MFN 08-086, Supplement 44

Subject: **Response to Portion of NRC Request for Additional Information Letter No. 126 Related to ESBWR Design Certification Application RAI Numbers 14.3-170 and 14.3-269**

**Response to Portion of NRC Request for Additional
Information Letter No. 126 Related to ESBWR
Design Certification Application
RAI Numbers 14.3-170 and 14.3-269**

Figure 1

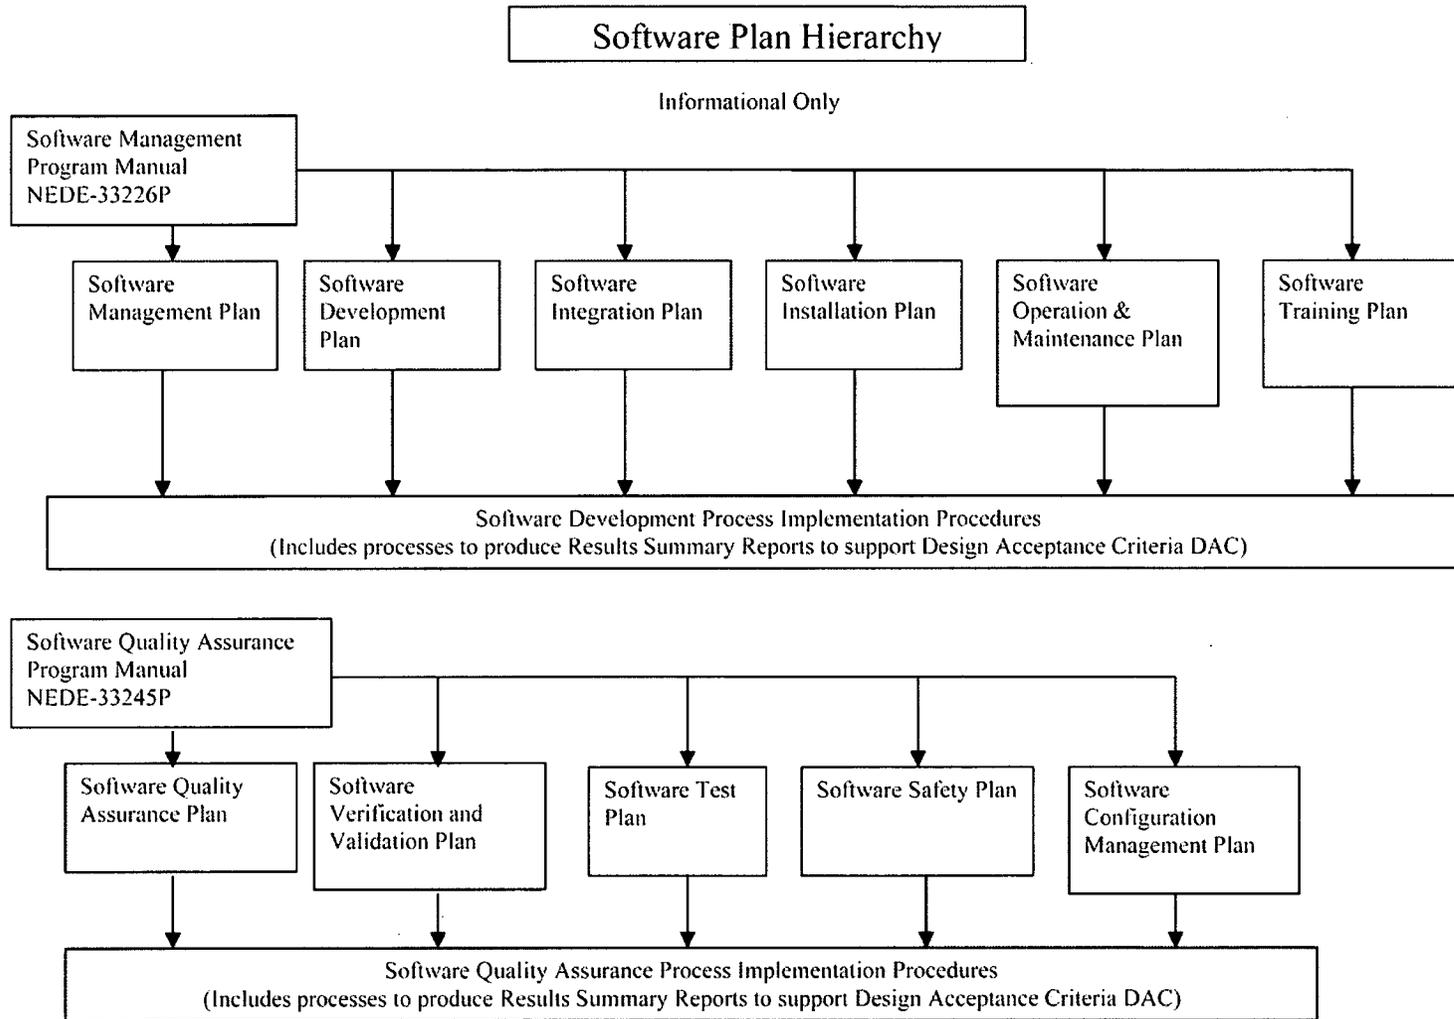
1. Please properly identify which ITAAC under this section are DAC.
2. There are multiple ITAAC/DAC plans listed. However, based on submitted Topical Reports, there will be three umbrella plans (SMP, SQAP and Cyber Security), which will provide guidance for the application specific implementation plans detailed in the ITAAC/DAC. Three of the umbrella plans have the same name as the plans to be developed and listed as per the ITAAC/DAC. Please clarify the naming convention for the umbrella/template versus application specific implementation plans and explain the expected hierarchy of the plans. For example, the currently submitted high level umbrella/template SMP shows several of the other listed plans as actually being its components. It is somewhat unclear which plans are to be standalone and which are subparts of other plans. And please confirm Staff understanding of the utilization of the umbrella/template plan versus application specific implementation plans as discussed here.

1. For GEH DAC/ITAAC discussion see response to RAI 14.3-107, also included in this letter.
2. The Submitted License Topical Reports (NEDE33245P and NEDE33226P) contain high level planning documents for the ESBWR software development and quality assurance processes. These are not implementation procedures. Implementation procedures will be developed as subordinate documents to these plans. The implementation procedures will be written once the NRC approves the License Topical Reports. As such, they will be in full compliance with the governing plans. The purpose of the subject License Topical Reports is to provide a traceable and verifiable licensing basis for the development of implementation procedures that will be used for the development and maintenance of all ESBWR class Q, N3, and N2 software applications.

Figure 1 represents the hierarchal structure of these documents and shows the intended implementation path forward. This figure is informational only and will not be included in the subject License Topical Reports.
